40 CFR 190
ENVIRONMENTAL RADIATION PROTECTION
REQUIREMENTS FOR NORMAL OPERATIONS
OF ACTIVITIES IN THE
URANIUM FUEL CYCLE

FINAL ENVIRONMENTAL STATEMENT

U.S. ENVIRONMENTAL PROTECTION AGENCY
Office of Radiation Programs

IX. RESPONSE TO COMMENTS

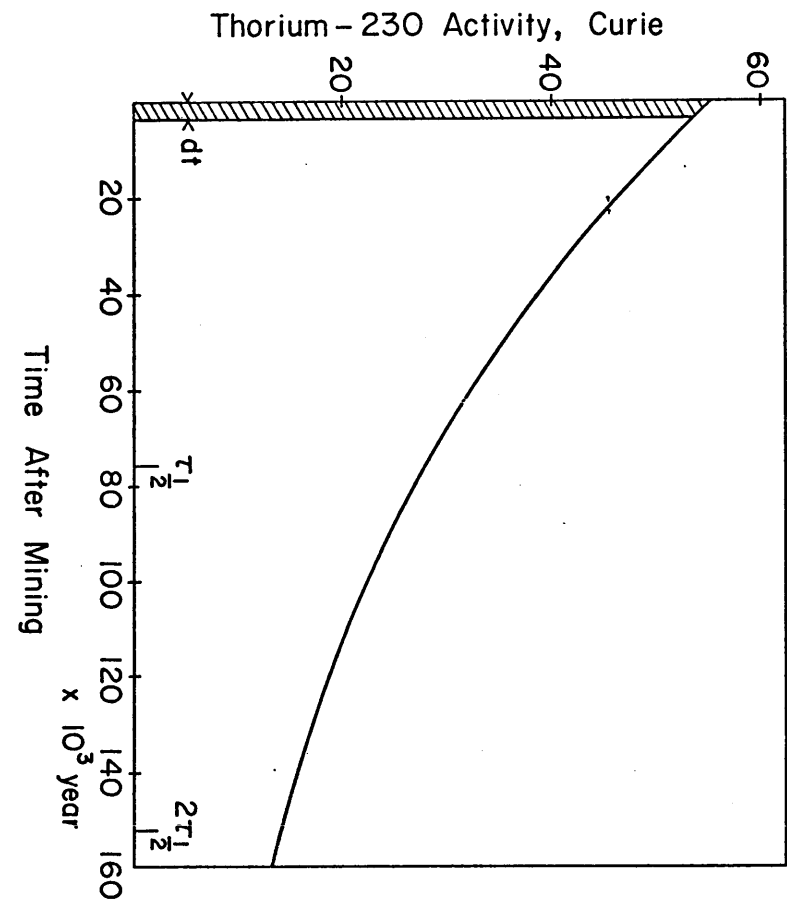
Now, however, comes the important point: The isotope from which the radon and its daughters are produced in the mill tailings is the very long-lived isotope thorium-230. During the 100 years considered in the EPA report, only a minute fraction (dn/n_0) of the thorium-230 will have decayed, namely 0.091%. The rest will decay later, with an exponential time dependence, as illustrated in Fig. 1. The number of thorium nuclei which decay during the first 100 years is represented by the area of the trapezoid under the curve as indicated, of the width $dt = 100y$; on the scale of the drawing, this width is actually invisibly narrow. Hence, the total number of health effects to be expected will be larger by the ratio of the total number of thorium-230 nuclei originally in the pile divided by the number of nuclei which decay during the first 100 years, or by the ratio of the area under the curve out to an infinite number of years divided by that of the trapezoid. Hence, the health impact resulting from the thorium-230 is $F_{Th-230}^{W=0.36/0.091\%} = 396$ deaths/GW(e)y (9).

A: The activity of the thorium-230 set free by burning coal follows the exponential time dependence shown in Fig. 1, except that, per GW(e)y, the scale on the vertical axis will be 50 times smaller. The uranium in the ash, however, will cause the thorium activity to remain constant for the order of a billion years, since the decaying thorium-230 is constantly replenished by the uranium-238. Of course, the same problem will be encountered with the uranium-238 presently stored at the nuclear fuel enrichment plant, unless ways are found of either burning it in a breeder, or else disposing of it safely.
